SUBJECT PROJECT CONCEPT REPORT APPROVAL - WIDENING OF FLINT RIVER ROAD

SUBJECT WIDENING OF FLINT RIVER ROAD - PROJECT CONCEPT REPORT

FILE MR-9107 (2) Clayton County OFFICE Atlanta, Georgia
P.I. No. 751810
Widening of Flint River Road - 3.03 miles DATE January 30, 1991
FROM Robert E. Humphrey, Project Review Engineer **REH-10**
TO William J. Durrence, Director of Preconstruction
SUBJECT PROJECT CONCEPT REPORT

SUBJECT REVIEW OF CONCEPT REPORT

FIGURE NO. 6

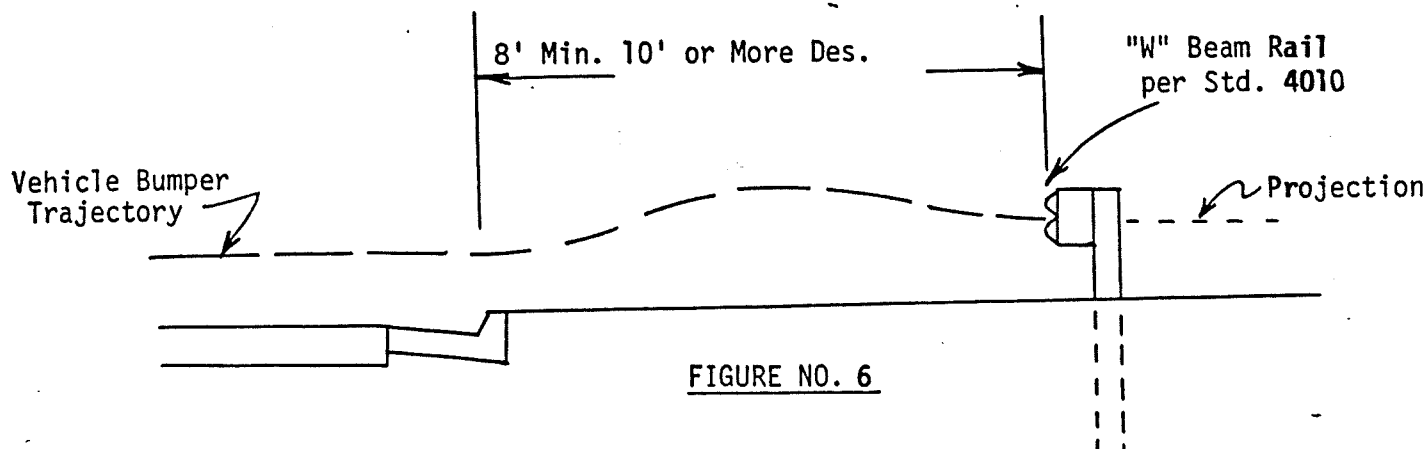
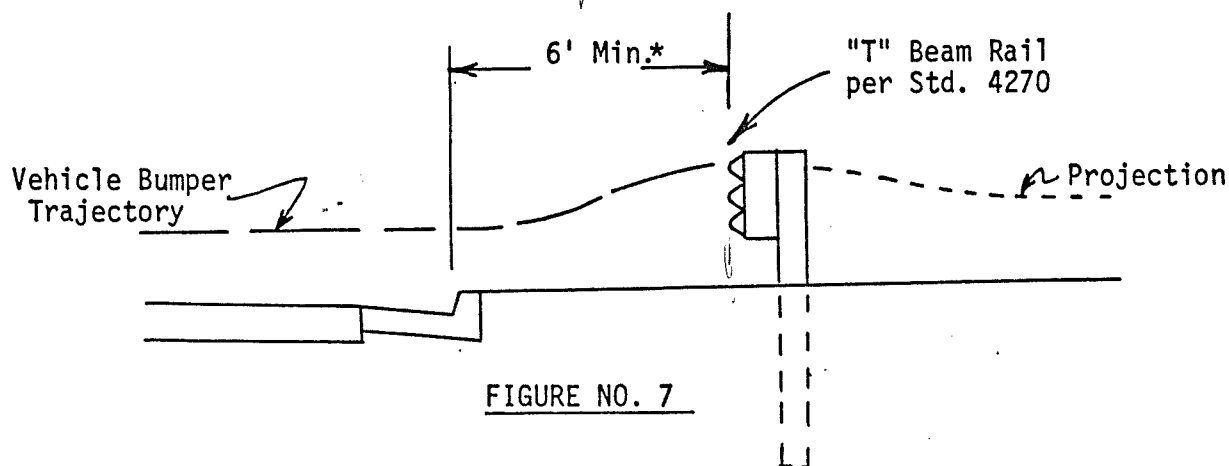
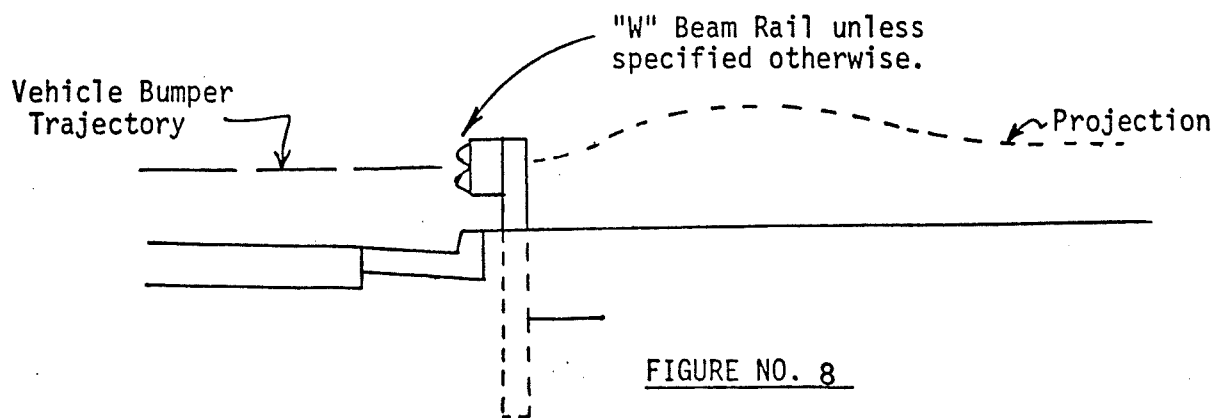
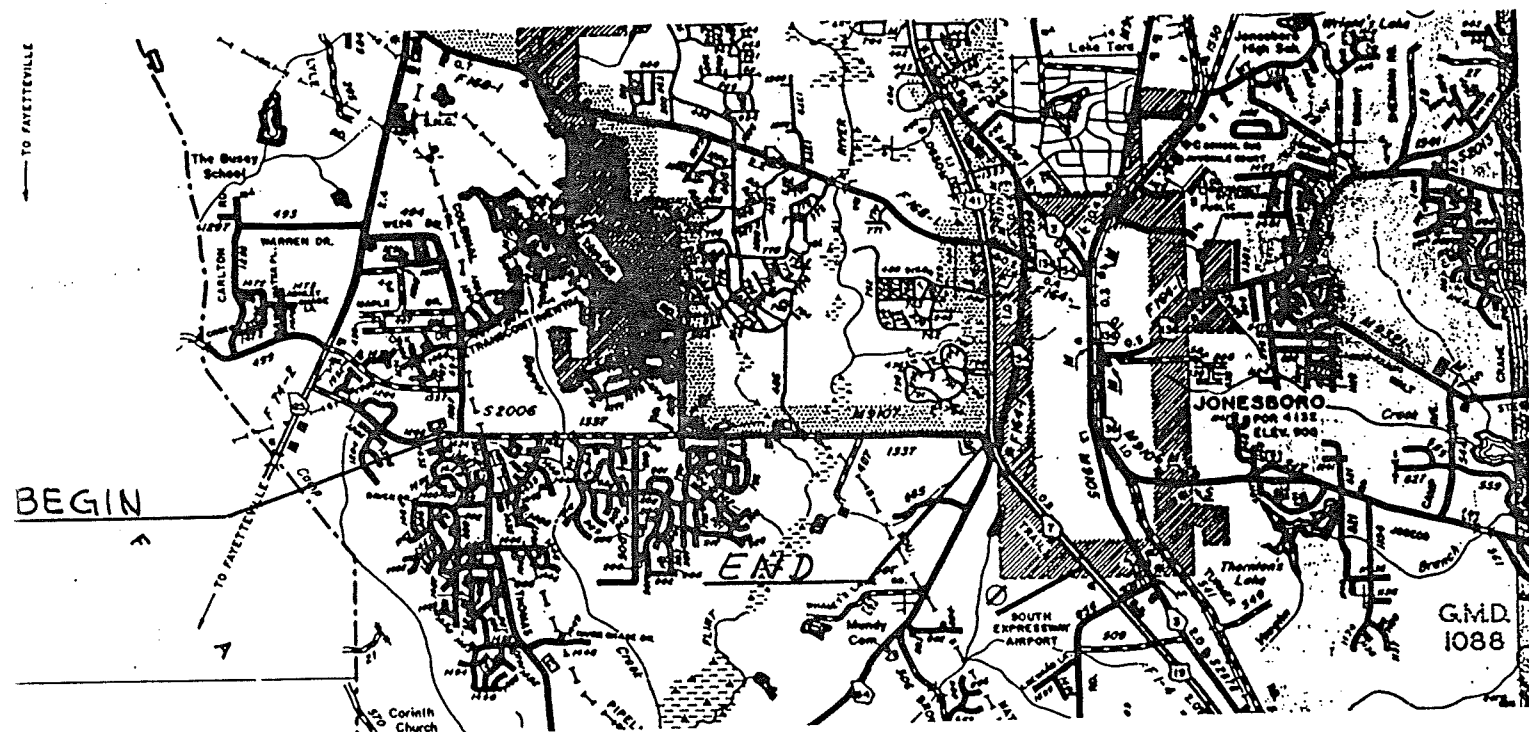
Reference is made to the attached concept report concerning the proposed widening of Flint River Road over Flint River. The concept report calls for utilizing the existing 68 ft. bridge width to provide a four lane section with a four foot raised median and four foot sidewalks on each side. The Bridge Office does not approve of this concept as four foot sidewalks on bridges are unsafe and do not meet our design policies. (See Attachment). We recommend that consideration be given to providing 6 ft. sidewalks for this structure.

In regards to our discussion with Bill Purcell concerning Paul Liles' January 29, 1991 letter, we concur with the State Bridge Engineer's statement that the four foot distance from the face of curb to the bridge railing does not meet our design policy for curb offset from a protective barrier. We recommend using a 6 ft. offset from the face of curb to the barrier wall. We also recommend keeping the 4 ft. concrete median through the bridge section.

This would require the use of 11 ft. lanes if the 68 ft. bridge is to be retained, which we would find acceptable in this instance.

PROPOSED ROADWAY SECTION ON EXISTING BRIDGE
OVER FLINT RIVER ROAD.

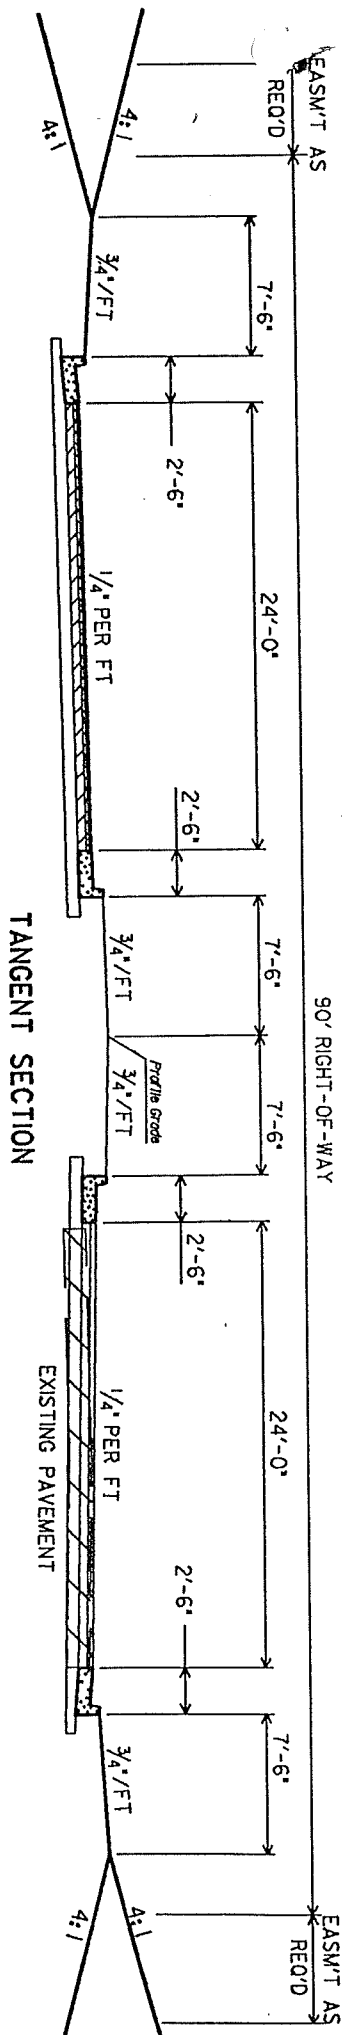
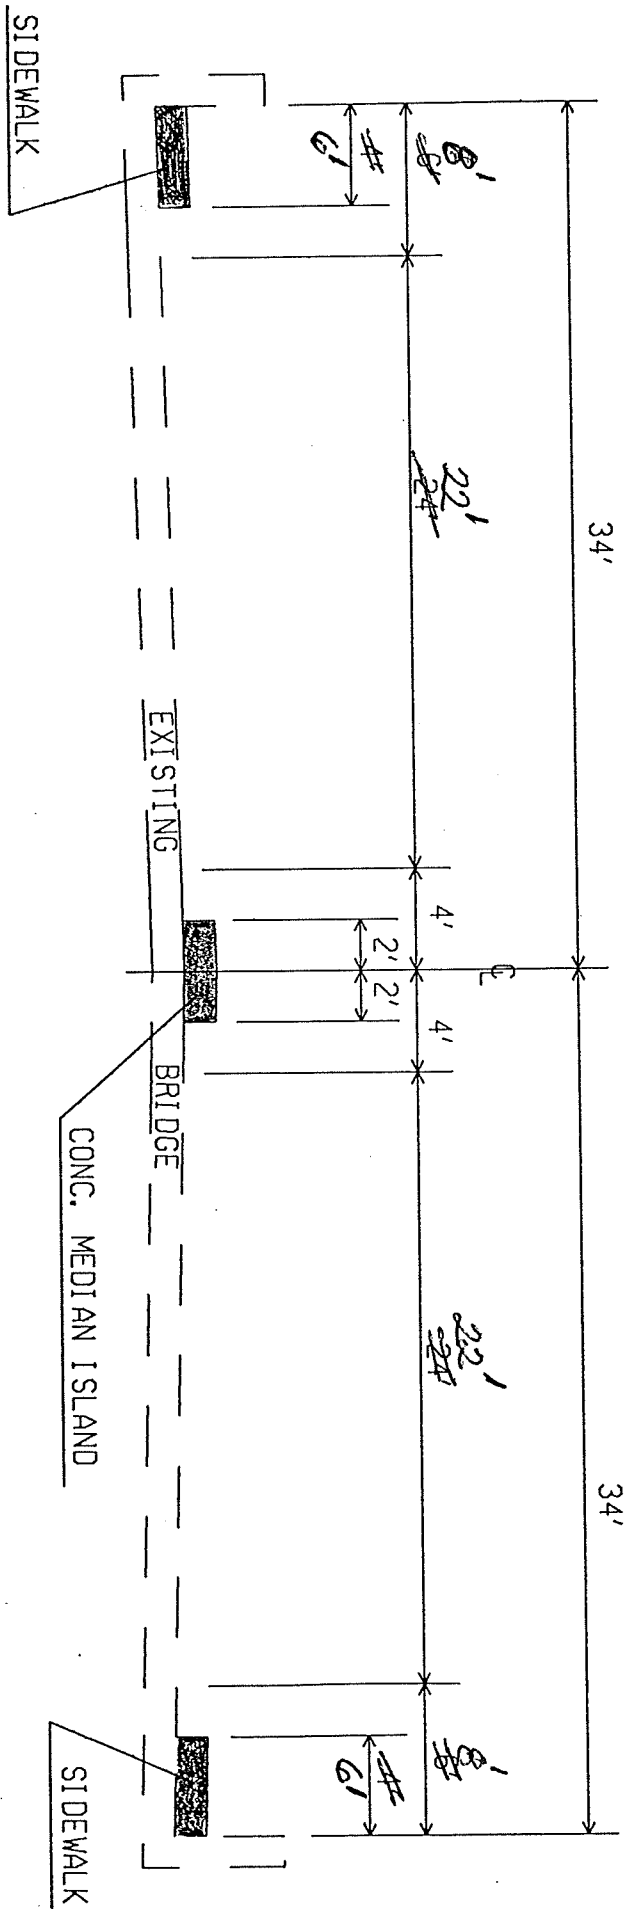
- 1) Traffic and Safety recommended deleting the proposed median opening in front of the church east of Roberts Road and look at placing openings at the western and eastern limits of the housing authority complex.
- 2) The existing bridge over the Flint River is 68 ft. wide. It is proposed to provide a 4 ft. raised median and 4 ft. sidewalk on each side of the bridge.
- 3) It was noted that several lakes are adjacent to the proposed right of way that may require restoration.
